PI 1521

PRODUCT INFORMATION

MERCEDES-BENZ IN-TANK MODULES

REPLACEMENT PART SOLUTION FOR CLS- AND E-CLASS

Fig. 1: Comparison of fuel delivery modules

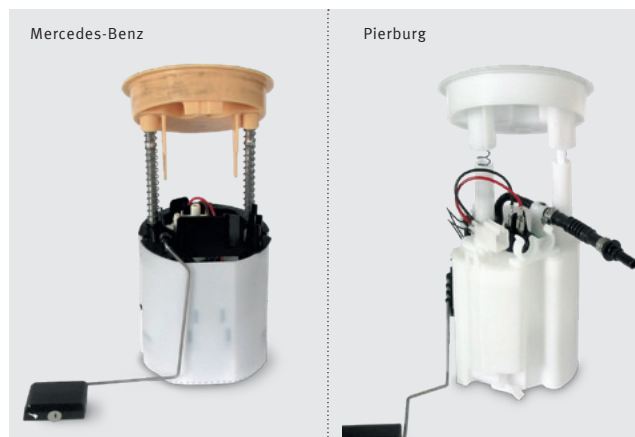
- The fuel delivery module from Motorservice features carbon-carbon commutation and therefore conforms to regulation E10.
- The fuel delivery module from Motorservice has a lower current consumption with the same performance (4.4 bar at 13.5 V).

Motorservice: 100 W, 7 A

Manufacturer: 162 W, 12 A

Fig. 2: Comparison of fuel tank sender units

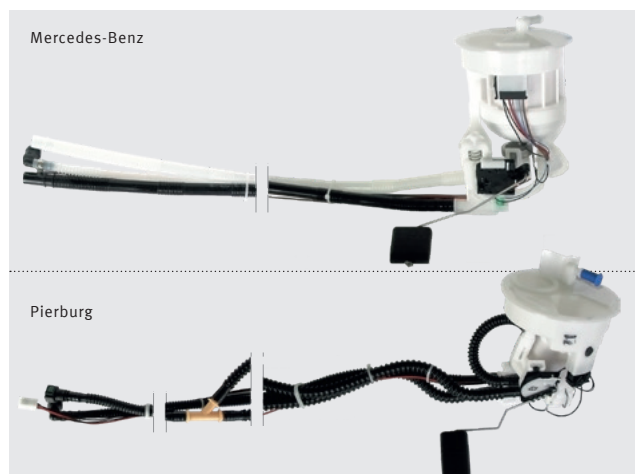
- On the fuel tank sender unit from Motorservice, both return lines are joined into one line by a Y-connector.

Fig. 5: Flange cover of the fuel tank sender unit

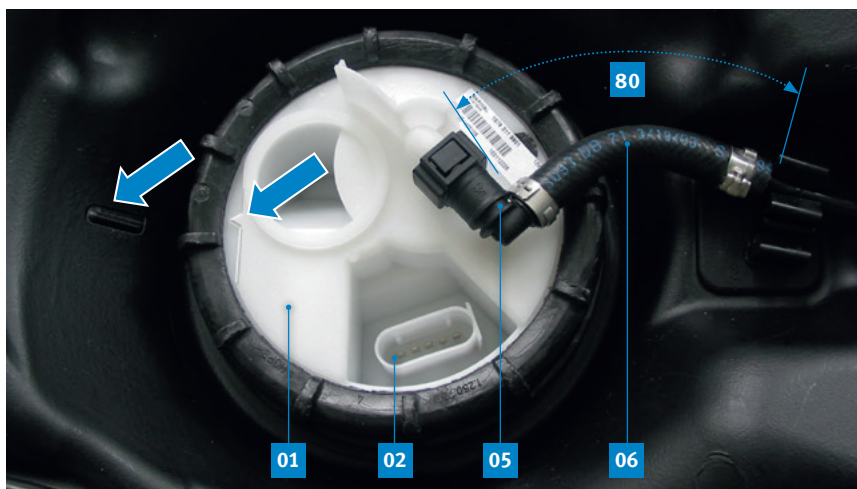
Insert the fuel delivery module and fuel tank sender unit into the fuel tank so that the arrow on the flange cover points towards the marking on the fuel tank (Fig. 5).

When replacing the fuel tank sender unit (01), the piece of tubing (06) of the flow line must be shorted to approx 80 mm, and the 90° quick connector (05) enclosed must be mounted (Fig. 5).

Fig. 7

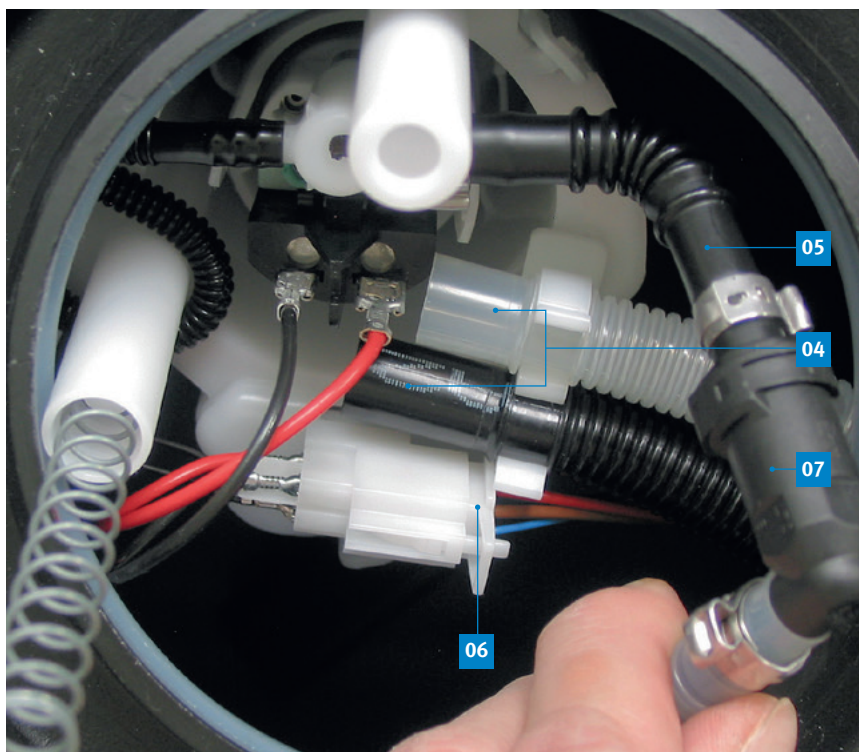
This installation position is encountered if you are only replacing the fuel delivery module (Fig. 7):

- Connect pressure line to the straight piece of tubing (05) of the fuel pump with 90° quick connector (07).
- Clip 2 return lines (04) onto the fuel delivery module.
- Insert plug (06) of the electrical line leading to the fuel tank sender unit into the fuel delivery module.

Fig. 9

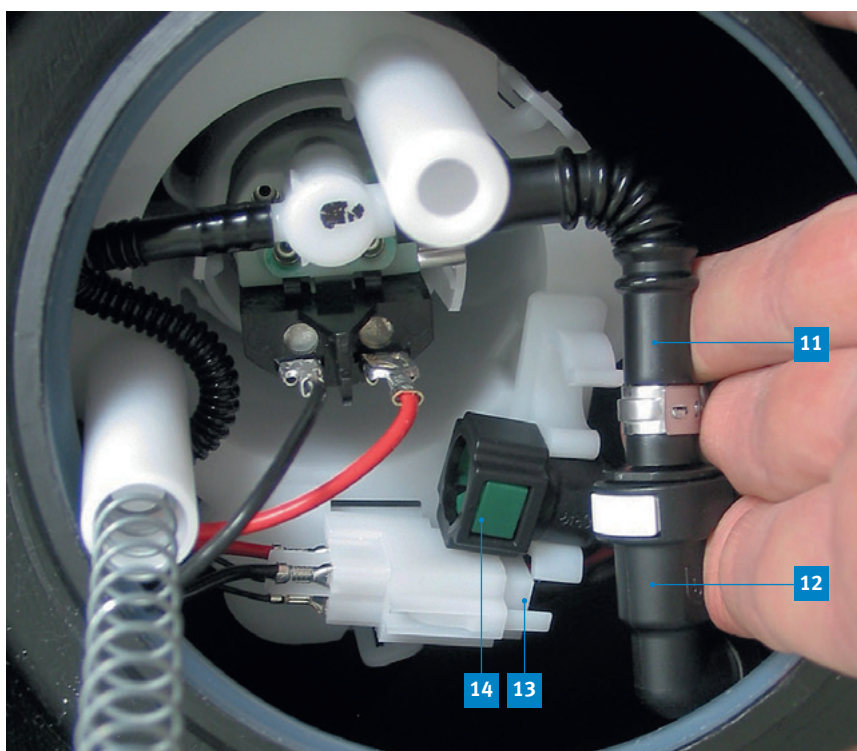
This installation position is encountered if you are replacing both the fuel delivery module and the fuel tank sender unit (Fig. 9):

- Connect pressure line to the straight piece of tubing (11) of the fuel pump with 90° quick connector (12).
- Clip 1 return line (14) into one of the two free supports on the fuel delivery module using a straight quick connector.
- Insert plug (13) of the electrical line leading to the fuel tank sender unit into the fuel delivery module.
